**Re: 45 Grenoble Drive Response to Transportation Comments**  
**City File#: 24 253098 NNY 16 OZ**  
**Project No.: 300058194.0000**

R.J. Burnside & Associates Limited (Burnside) has reviewed the City of Toronto (the City) transportation related comments within the following documents:

**Figure 1: Existing Traffic Volumes Comparison**

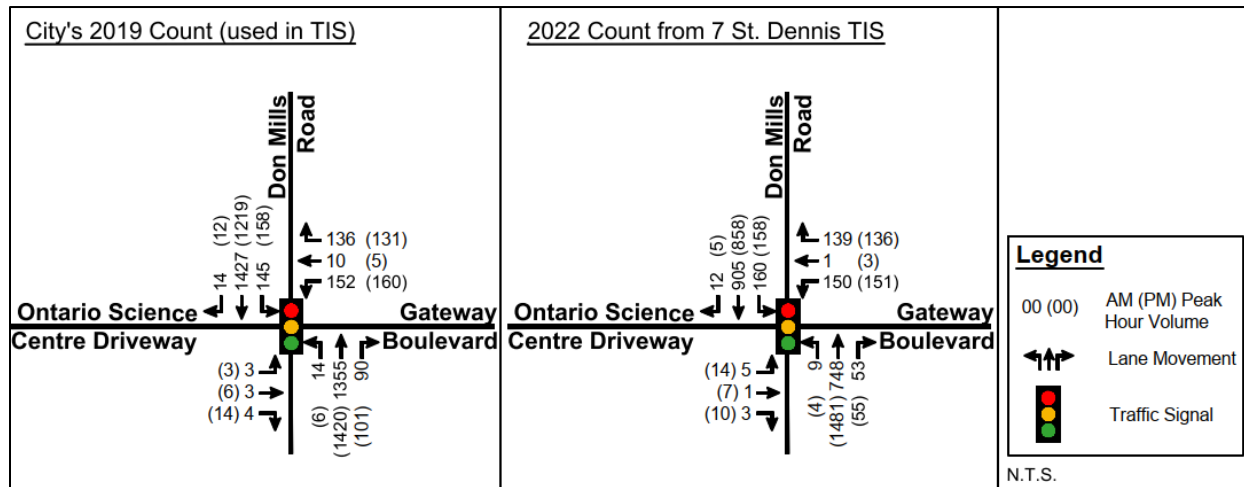
*The traffic counts for some study intersections utilized in the Transportation Impact Study (TIS) were acquired in 2019 and 2022, rendering them outdated for accurate analysis. It is imperative to provide updated traffic counts to ensure the reliability and relevance of the traffic analysis. Additionally, the revised traffic analysis should incorporate recent traffic data, such as counts conducted in 2023 or later, to reflect current traffic patterns and conditions accurately. This will enhance the accuracy and effectiveness of the assessment and ensure that the proposed development adequately addresses present traffic concerns and impacts.*

As shown in the TIS, a review of historical traffic count data indicated many intersections are experiencing either negative or no growth. Figure 1 illustrates a comparison between the existing traffic volumes used in the TIS and a March 23, 2022, count taken from the 7 St. Dennis TIS, dated August 2022, for the intersection at Don Mills Road / Gateway Boulevard. The comparison shows that all turning movement volumes, during both peak hours, are within a similar range, has similar patterns and several volumes used in the TIS are higher than those observed in the March 23, 2022, count. Note that COVID restrictions were all lifted in early March 2022. The traffic counts are provided in Attachment 5.

### Updated Site Plan

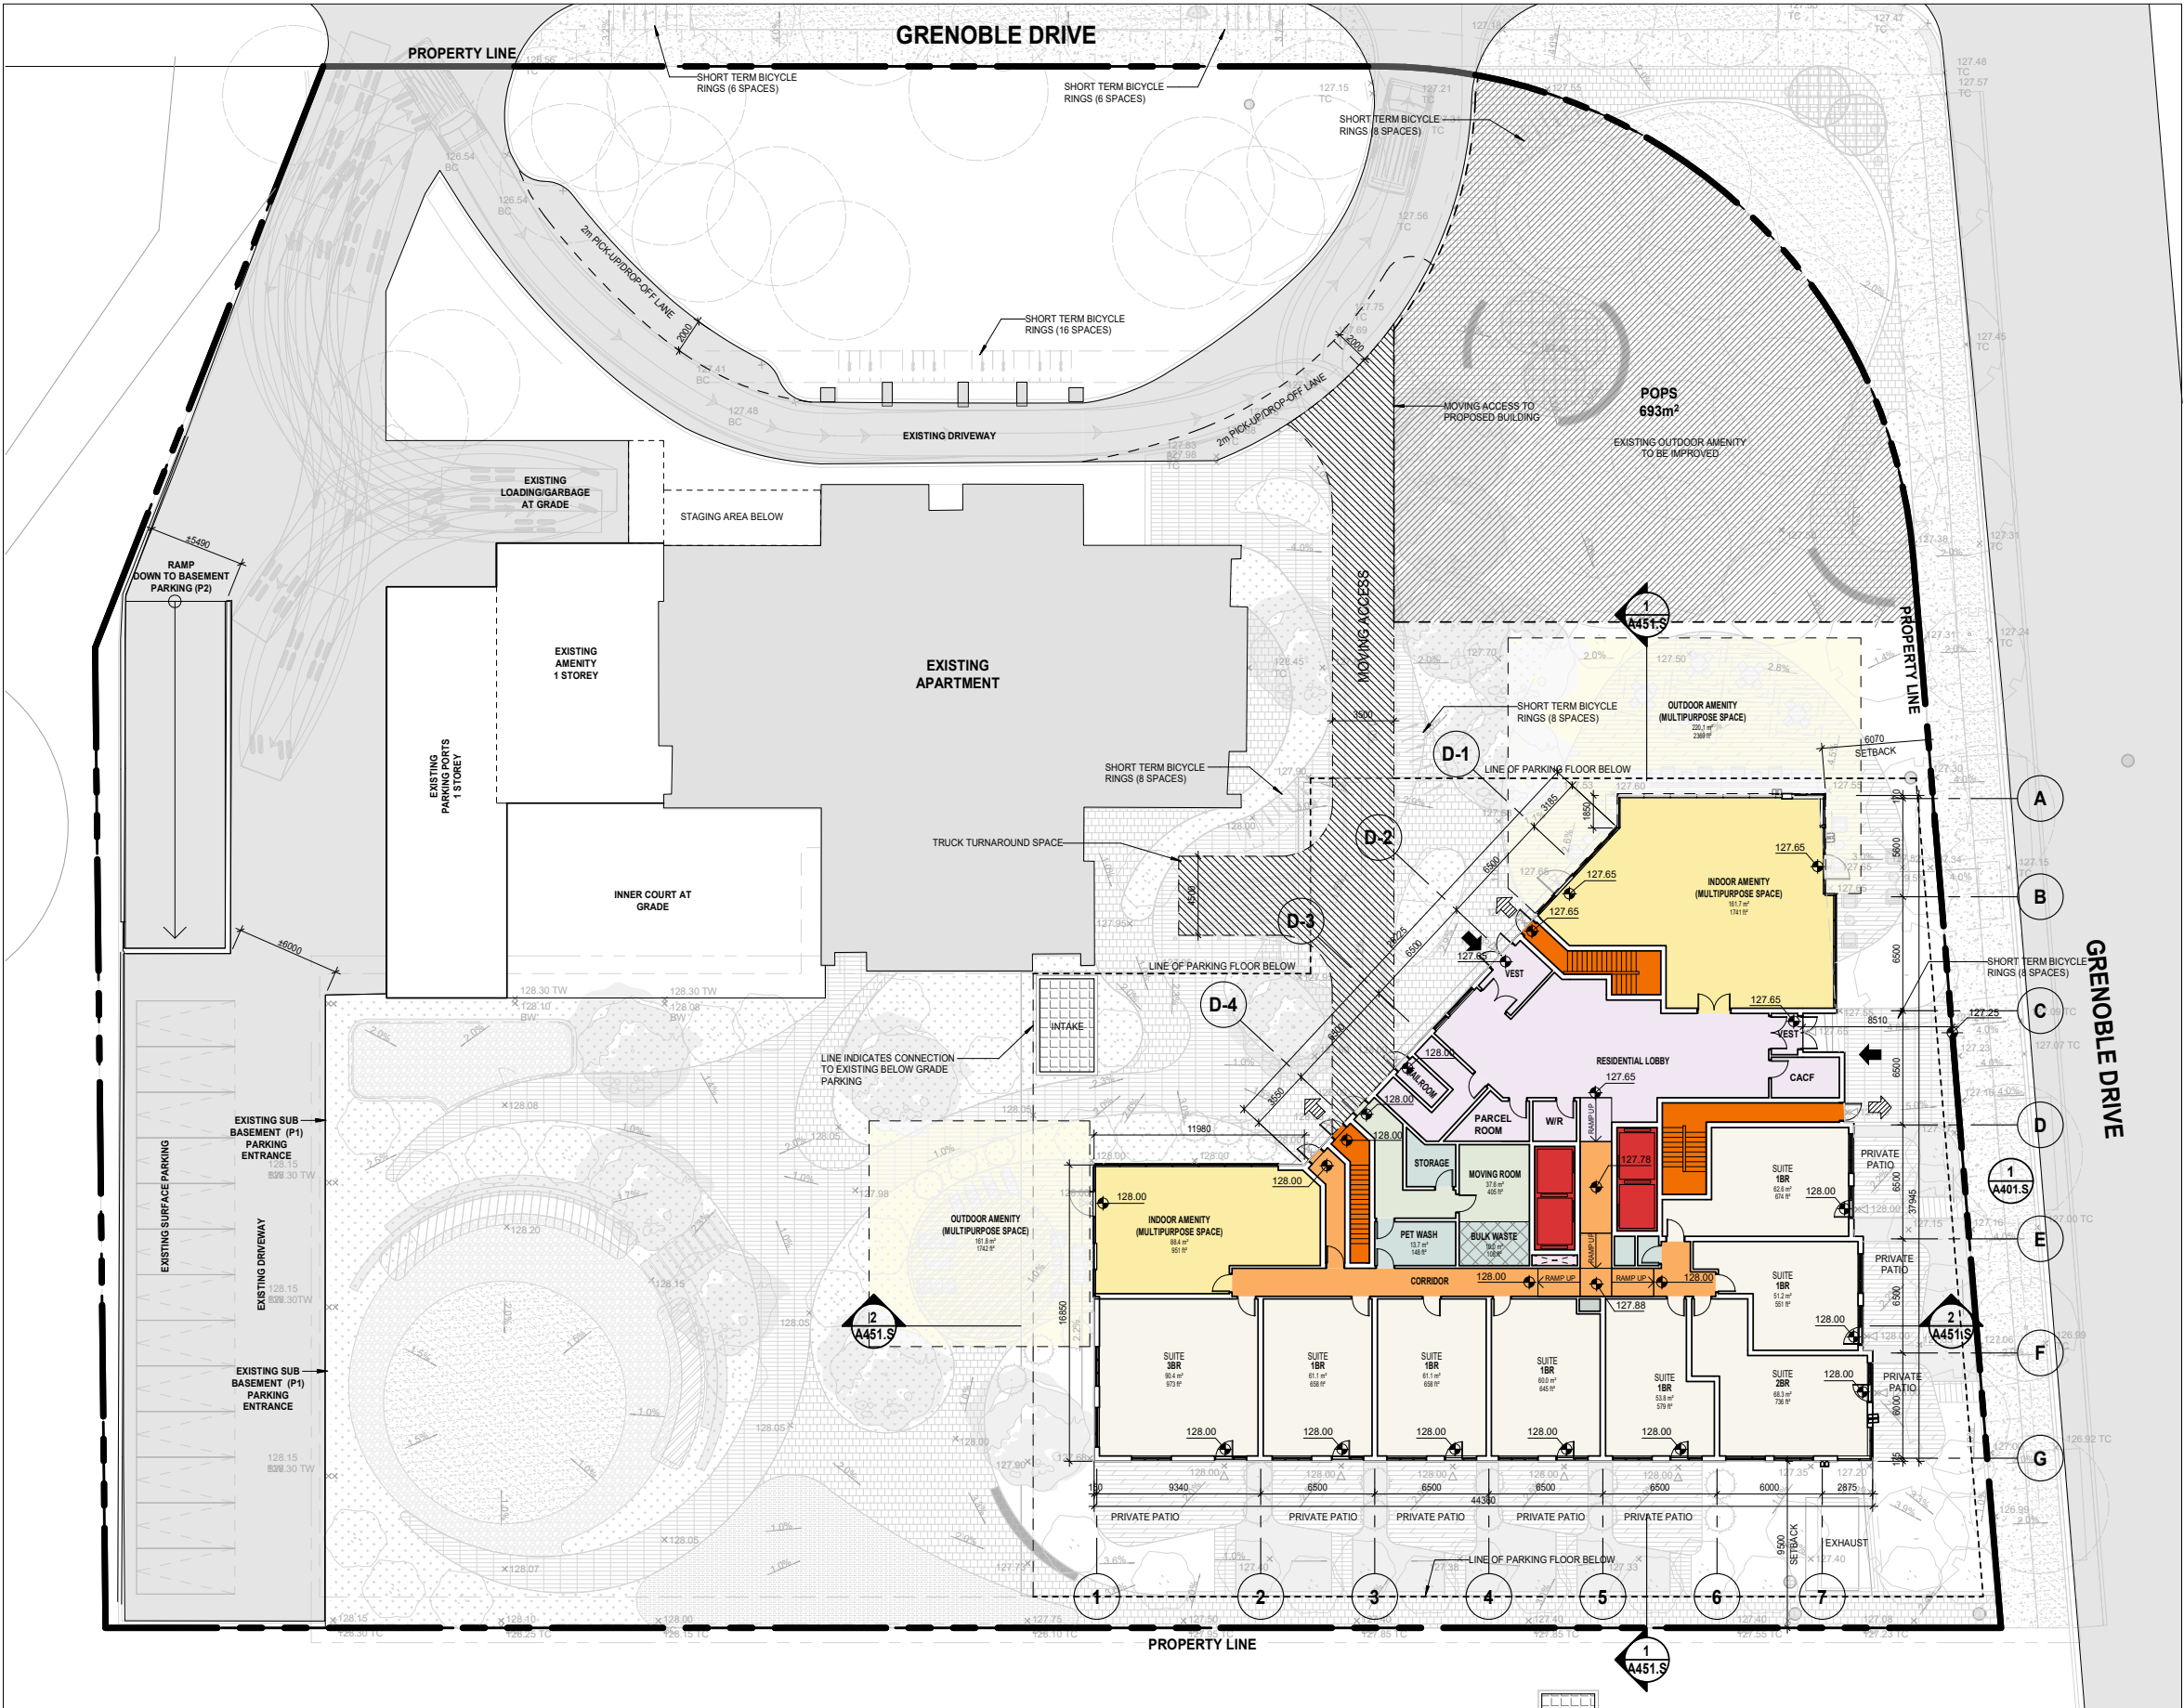
5. *The Site Statistics must be revised to provide clarification on the exact number of existing residential, visitor, and accessible parking spaces;*

6. *The legend of the Parking and Ground Floor Plans must be revised to incorporate the explicitly labelled typical dimensions for accessible parking and parking spaces as outlined in By-law 579-2017 and By-law 569-2013. Furthermore, the Parking Plans must also include the additional typical dimensions for accessible parking spaces and parking spaces adjacent to obstructions, such as walls and pillars that extend beyond 1.0m from the front or rear of the parking space, with an additional clearance of 0.3m on each side of the obstruction. Small car parking spaces will not be accepted;*

9. *Revise the Site, Ground Floor and Landscape Plans to show the provision of minimum 2.1m wide linear paths of concrete public sidewalks along all development site frontages, which:*

*Based on the Site Statistics, a total of 457 bicycle parking spaces are proposed, consisting of 92 short-term and 365 long-term spaces. However, the Ground Floor and Parking Plans currently label 376 long-term and 26 short-term bicycle parking spaces, which does not align with the Site Statistics. This discrepancy indicates a failure to meet the requirement. As a result, the Ground Floor and Parking Plans must be revised to accurately label all the bicycle parking spaces specified in the Site Statistics.*

*The Site, Ground Floor and Landscape Plans must be revised to remove the proposed bicycle parking spaces located within the public right of way and relocate to an on-site location.*

*Provide a context-sensitive pedestrian clearway that is a minimum of 2.1m wide, to safely and comfortably accommodate the pedestrian flow. This requirement has not been satisfied.*

Please see the updated site plan that shows the requested breakdown of parking spaces.

Please see the updated parking and ground floor plans that shows the requested details.

The updated site plan complies with these requirements.

Please see the updated site plan that fulfills these requirements. 26 short-term bicycle parking spaces are provided at the P1 level, and 66 short-term bicycle parking spaces are provided on the ground floor level.

The requested 2.1m wide sidewalks have been provided, as shown in the updated site plan.
